**Proposed SHD at Sandyford,
Avid Technology Site**

**STAGE 1 QUALITY AUDIT
(Incorporating a DMURS Street Design Audit, and
Audits of Accessibility, Cycling, Walking
and Road Safety)**

Waterman Moylan

June 2022

Figure 5 – Swept Path Analysis overhang above footway

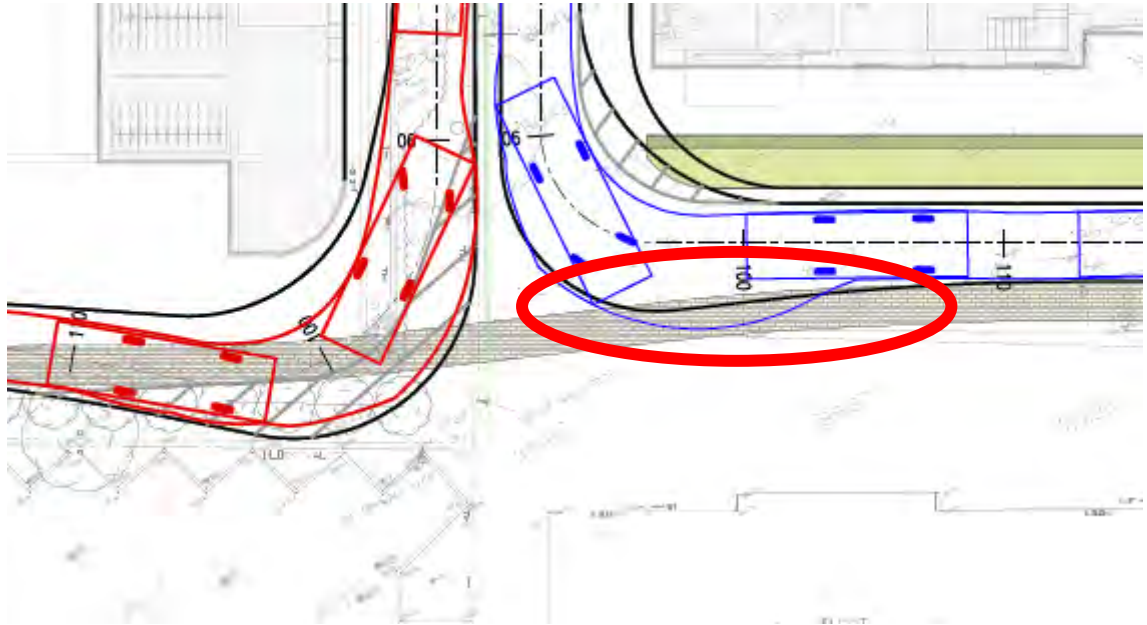
Based on swept-path analyses provided, larger vehicles appear to rely excessively on overhanging and driving over internal pedestrian footways (Figure 5) to make movements, resulting in increased risk of pedestrian injury.

Revise the street layout, footway layout and swept-path analyses to ensure adequacy for all movements and users.

Figure 6 – Sightline drawing showing location of interruption by Pedestrian Guardrail

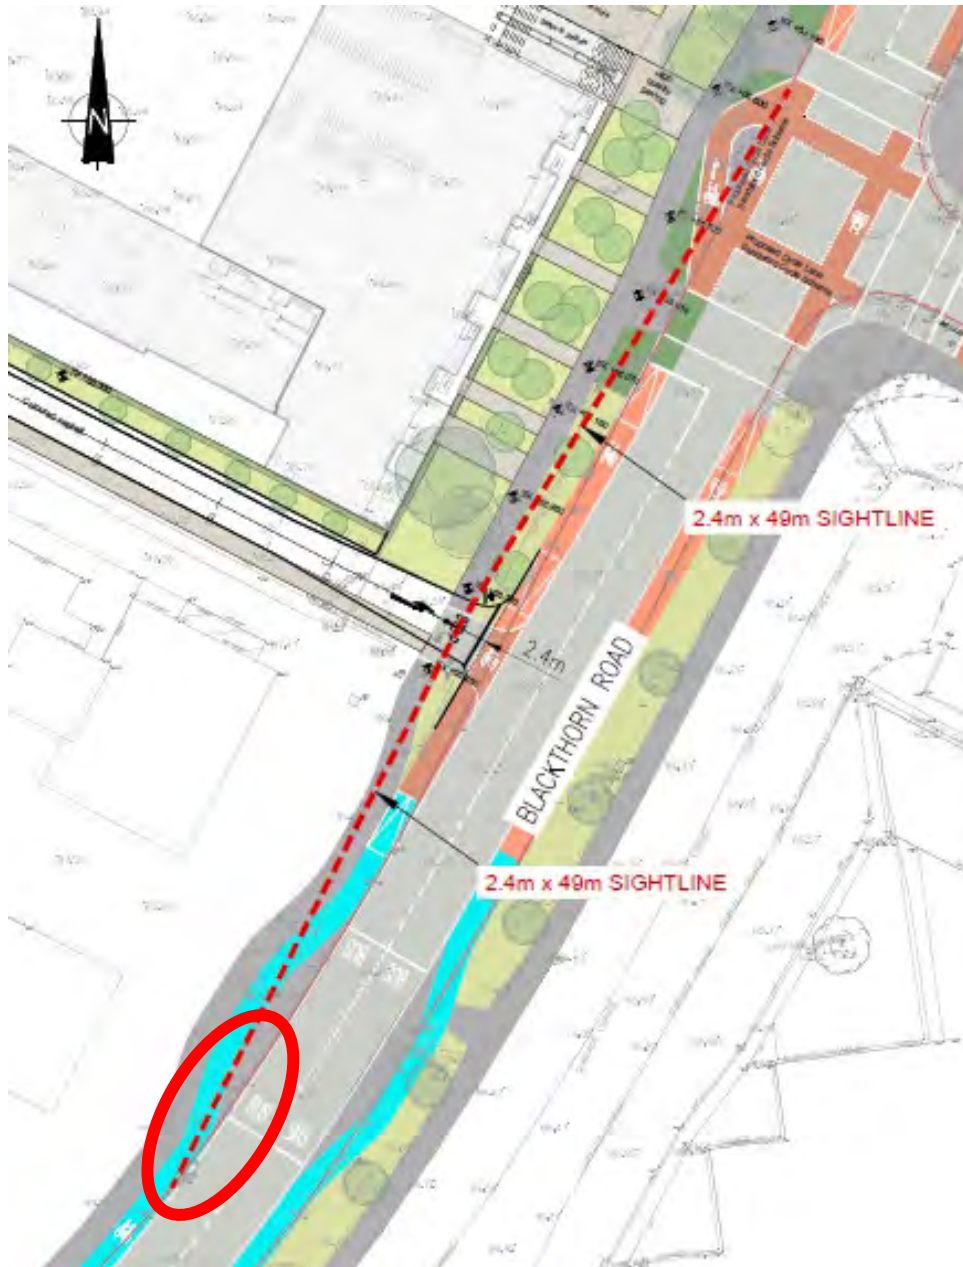
Based on drawings, it is noted the presence of a 49m visibility splay on the Blackthorn Road exit which contains a bus cage. The end of this visibility splay is however compromised by a pedestrian guard rail, as outlined in Figures 6 and 7. Exiting vehicles will have their sightlines compromised by stationary buses and the guard rail, increasing the likelihood of a collision with passing vehicles.

Revise the street layout at this location to provide adequate sightlines.

Figure 8 – Road layout at ramp

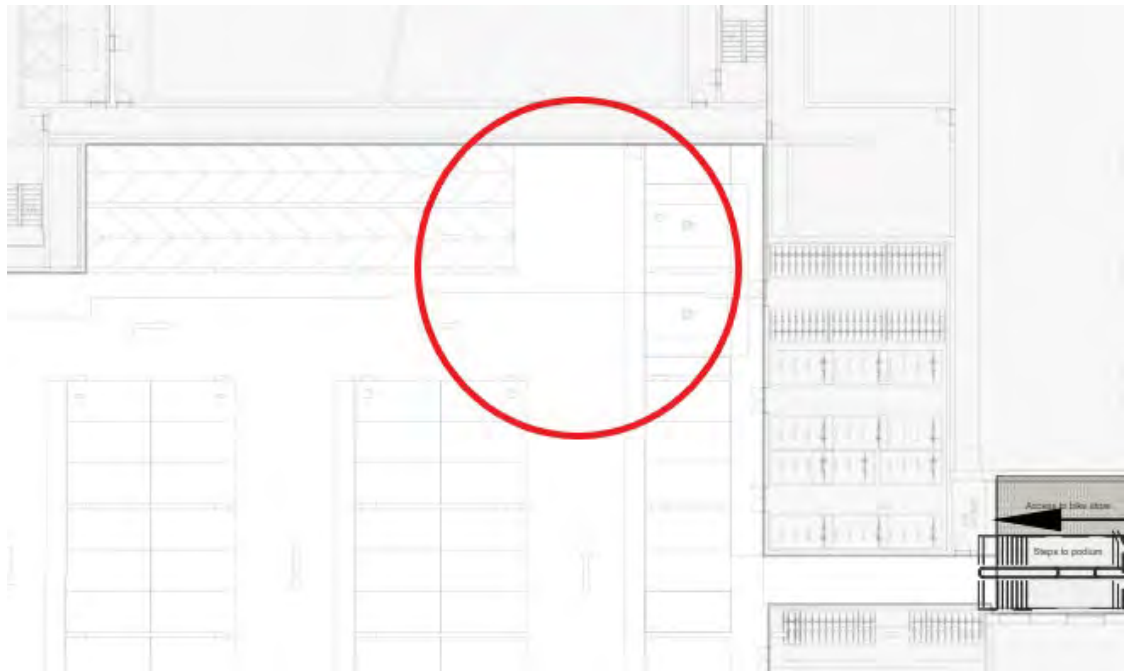
The road layout at the ramp in the basement carpark is unclear and drivers may be confused as to who has priority. In addition, it is unclear if vehicles can remain in lane when to and from the ramp at this location.

Revise the layout if necessary to ensure that priority at this location is clear and that vehicles can remain in lane when turning to and from the ramp.

Figure 10 – Kerb Lines shown differently to Figure 8.

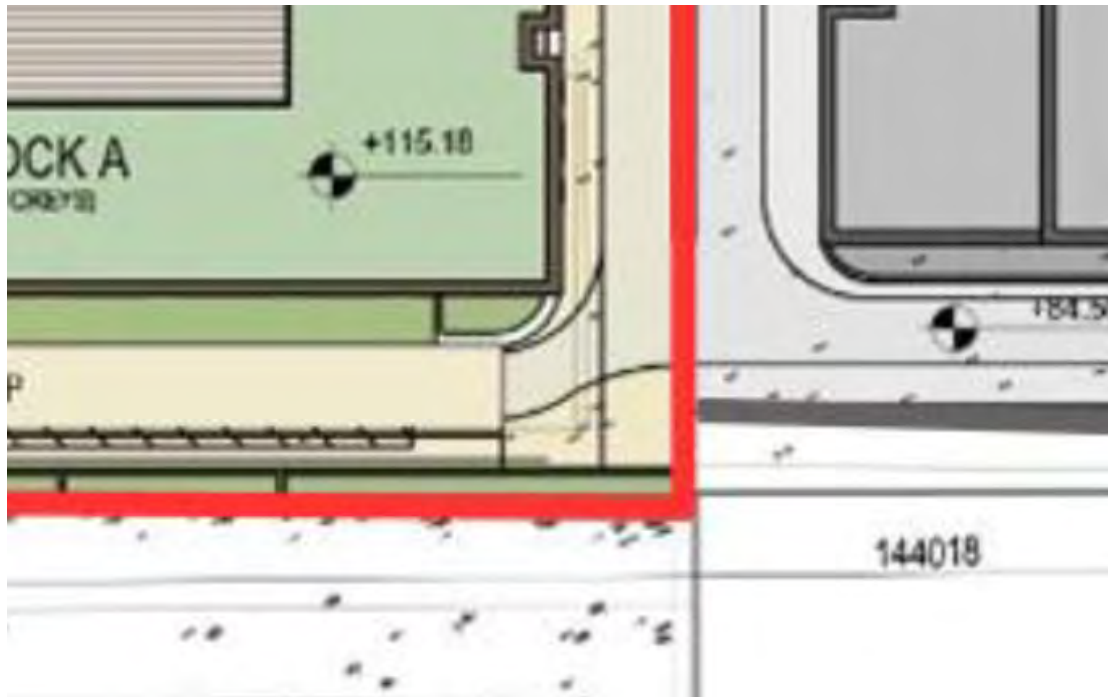
Figure 9 – Swept Path Analyses where vehicles are overrunning footways.

Provide adequate footpaths throughout the entire development.

DRAWN	DESIGNED	APPROVED	DATE
G.Byrne	BMC	JG	DEC '21
SCALE	JOB NO.	DRG. NO.	REVISION
1:250 @A1	21-118	P101

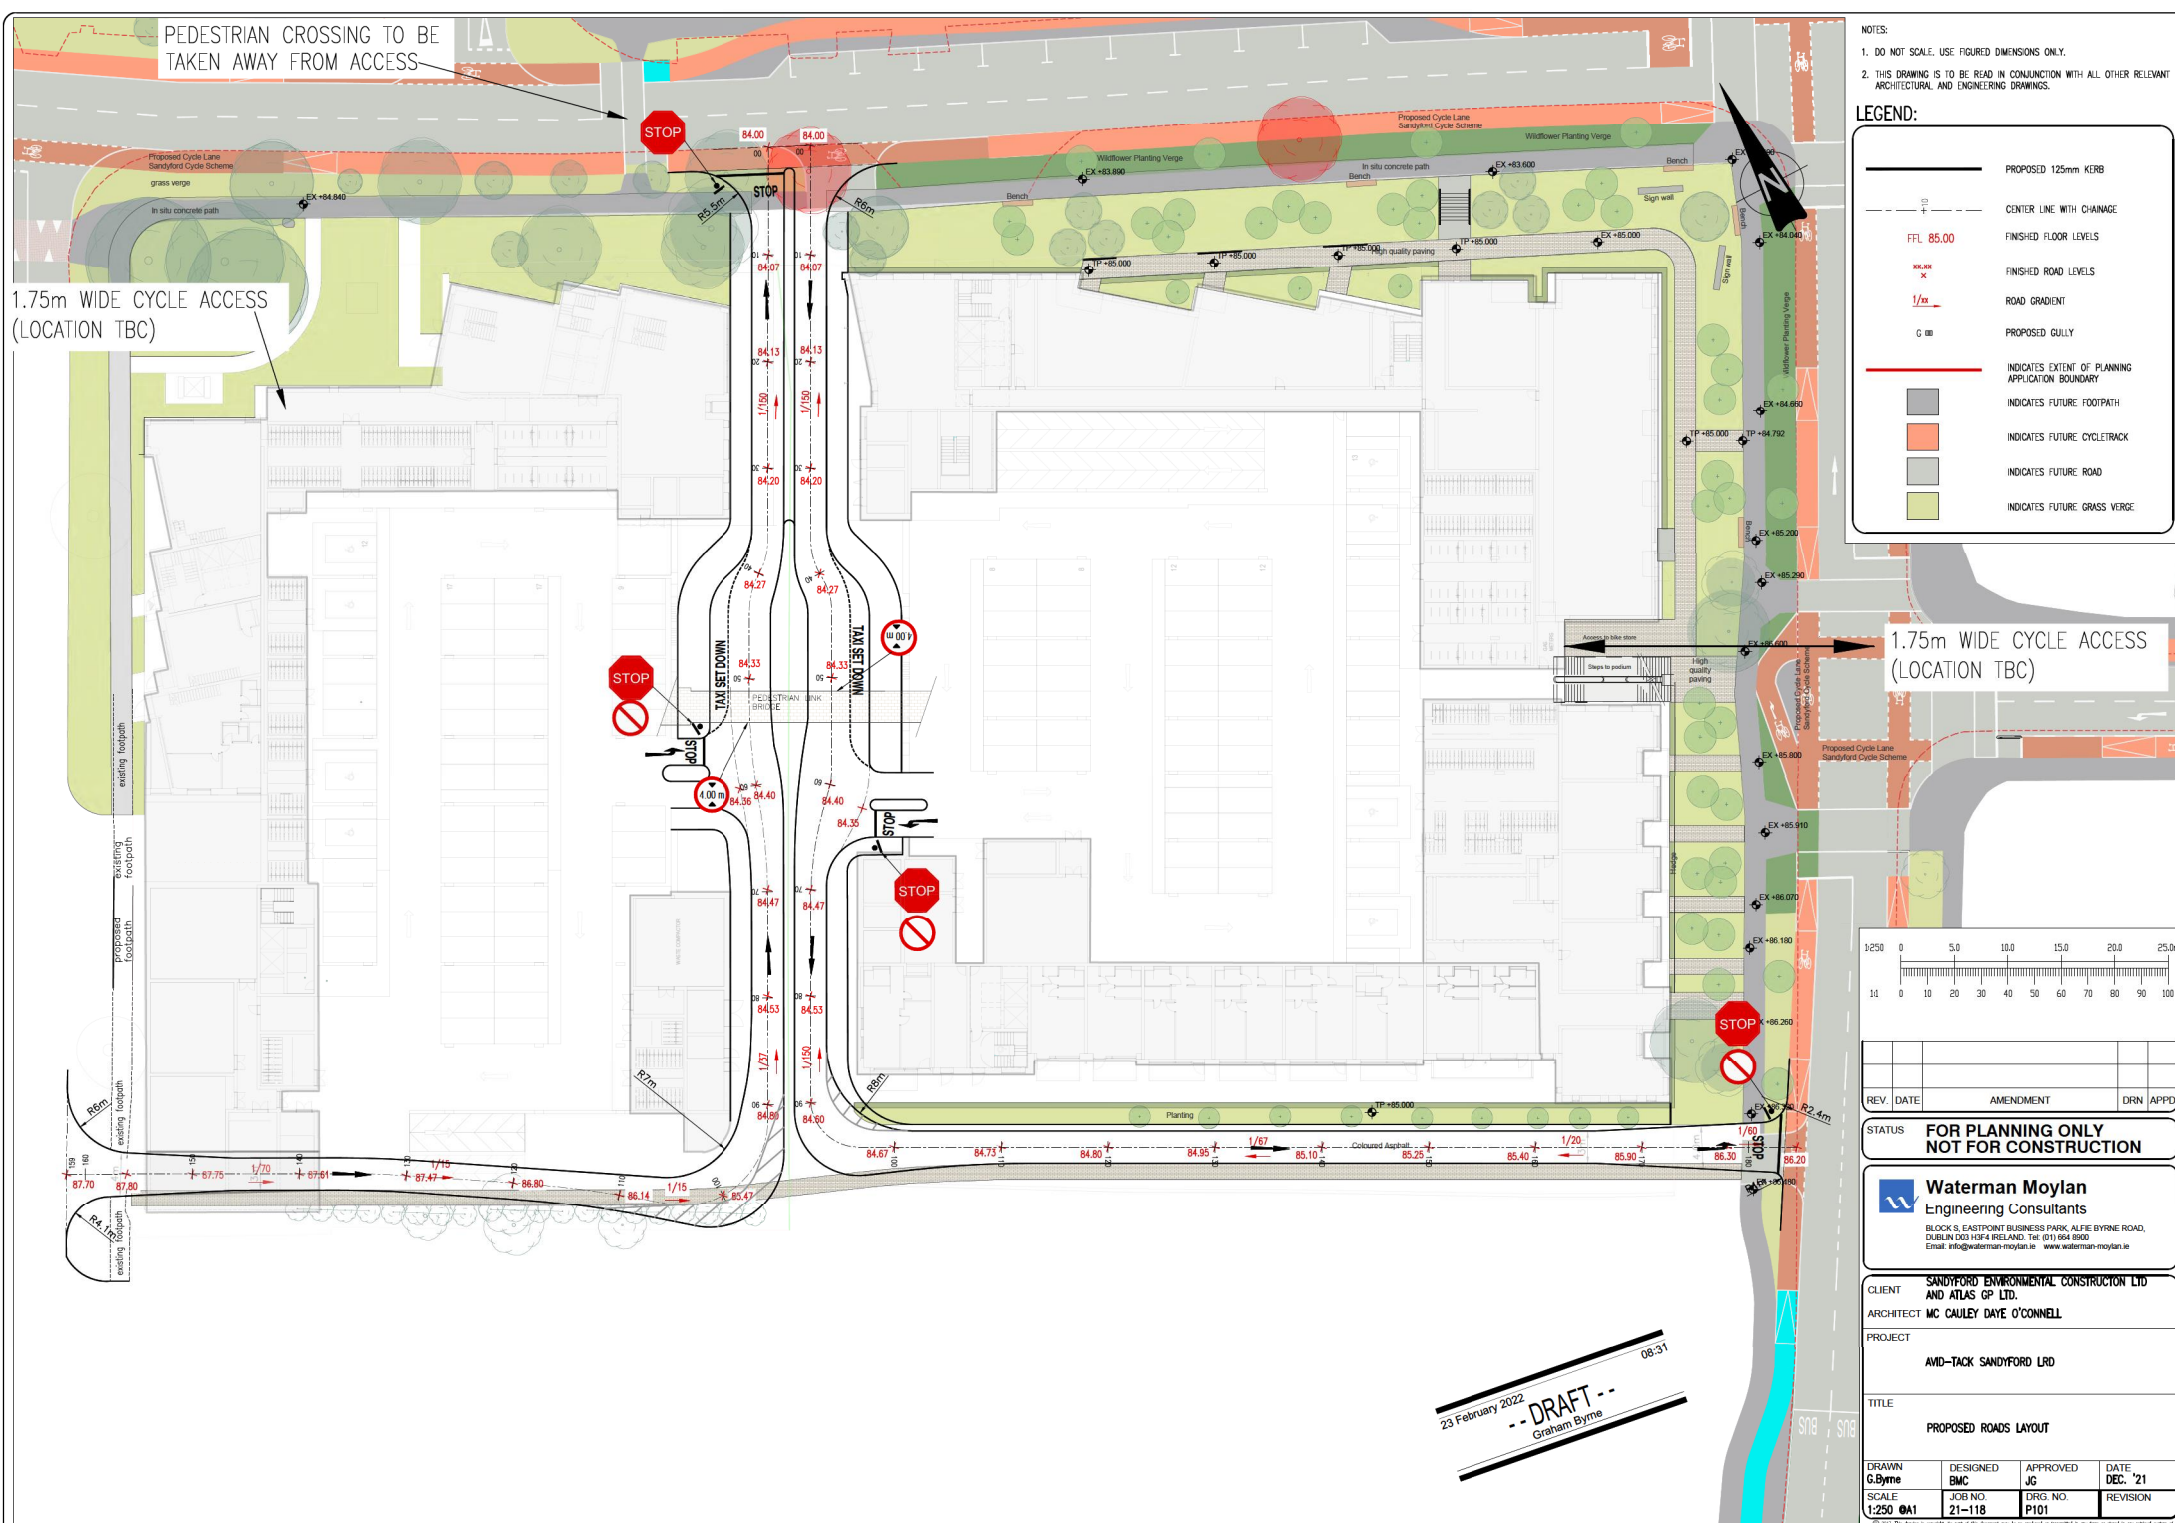
PEDESTRIAN CROSSING TO BE TAKEN AWAY FROM ACCESS
